Transmitted by the expert from the European
Commission

Informal document No. GRXX-xx-xx
(xx GRXX, x-x XXXXX 200x,
agenda item xx.)

DRAFT PROPOSAL FOR A HORIZONTAL REGULATION ON COUNTRY CODES, VEHICLE
CATEGORIES, DEFINITIONS AND SCOPES

4.7.2.2. ~~Power driven~~ Motor vehicles other than those referred to in paragraph 4.7.2.1 ~~6.2.1.~~ must be loaded to the technically permissible maximum mass stated by the manufacturer.

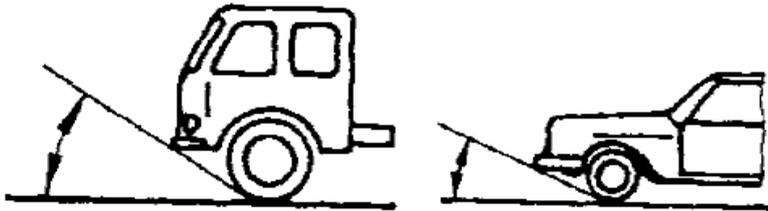
Comment: Where is that in the latest version of R.E.? 7.2.1.?
